Release Note

Edgecore EAP101 Release v12.5.5

Document # EAP101-v12.5.5-1431-e3f388a82

Enhancement from v12.5.3-1377-1c4ece372

1.1 Support U-APSD

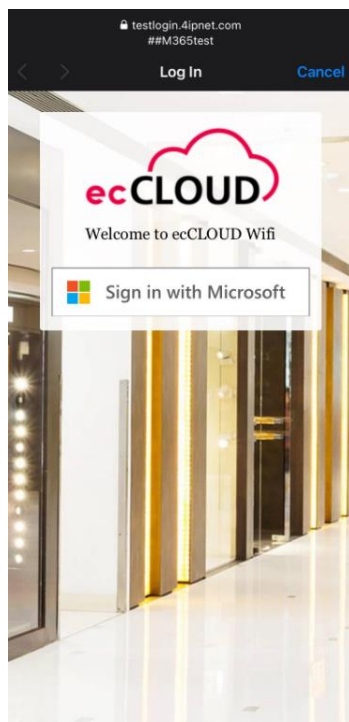
Support U-APSD on the Wireless page.

1. U-APSD: Enable or Disable U-APSD feature that is an 802.11 power save mechanism that works with WMM.
